**CONFIRMATION OF SEARS FOR SSD 8875 –
PITT STREET NORTH OVER STATION DEVELOPMENT CONCEPT SSD APPLICATION
&
CONFIRMATION OF SEARS FOR SSD 8876 –
PITT STREET SOUTH OVER STATION DEVELOPMENT CONCEPT SSD APPLICATION**

Appendix 1: Pitt Street South OSD Concept SSD Application – Draft Project Description

Figure 1 – Proposed Pitt Street South OSD building envelope (axonometric diagram from southeast).

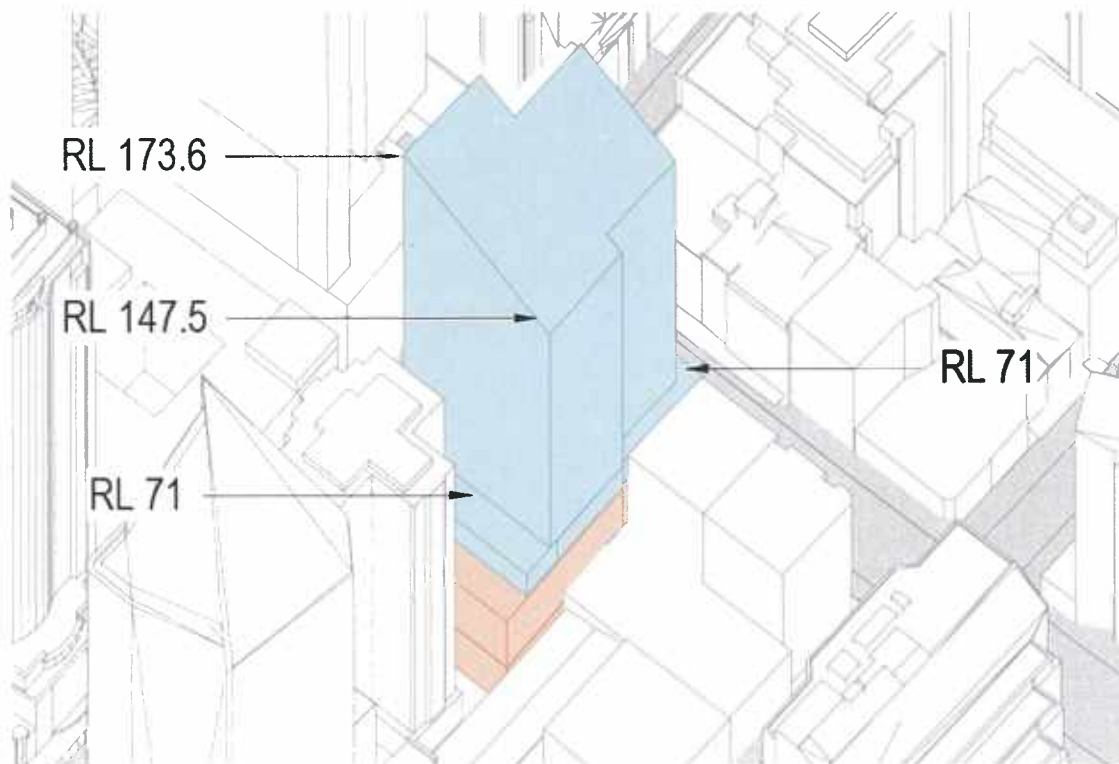
- a substantial reduction of building envelope height to RL 173.6, in order to comply with the sun access plane provisions under Clause 6.17 the *Sydney Local Environment Plan 2012*; and
- the inclusion of an additional potential land use for commercial office purposes, such that approval is now being sought for a building envelope and the conceptual use of the OSD component of the envelope for the purposes of:
 - residential accommodation; OR
 - commercial premises

- a building envelope as illustrated at Figure 1
- a maximum envelope height of approximately Relative Level (RL 173.6) which equates to approximately 35 storeys, including the podium height of RL 71 which equates to approximately 8 storeys above ground
